Contract
Facade Survey,
Sunlight House, Manchester, M3
3HP
(24008)

Drawing Title
Facade Condition Survey - Internal
Light well Elevations 5 to 8

Drawing No.
24008-PAYE-DR-006 rev P01

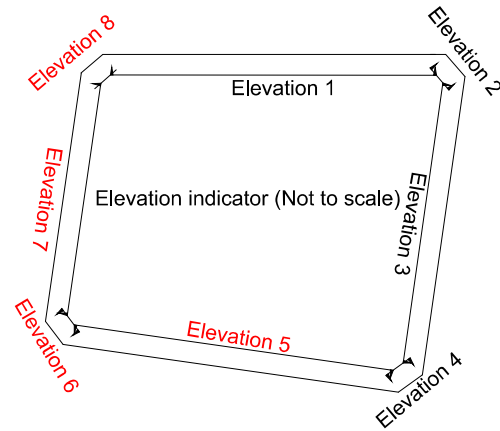
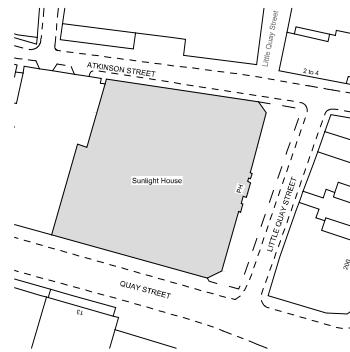
VEGETATION GROWTH OBSERVED TO THE BED JOINTS.
RECOMMEND 100% RAKING OUT AND REPOINTING

RECOMMEND 100% RAKING OUT AND REPOINTING

Hairline fractures were observed to localised areas. The cause for the fractures is possibly settlement of the facades. Recommend consultation with a structural engineer and continued monitoring as part of the Pre-Planned Maintenance.

Rust staining was observed to several lintel and windowsills at L13. The cause for the rust staining is likely corrosion of the steel lintels which has washed down the window to the windowsill. Recommend consultation with a structural engineer and up-close inspection once access scaffold is available.

Vegetation growth was observed to one gutter.

Hairline fracture or fractures were observed to several windowsill. The fractures could be to the stone sill (and possibly caused by differential settlement of the façade) or could just be flaking paint. Recommend up close inspection once scaffold is available.

Hairline fractures - originating from the windowsill - were observed to localised areas. The cause for the fractures is possibly settlement of the facades. Recommend consultation with a structural engineer and continued monitoring as part of the Pre-Planned Maintenance.
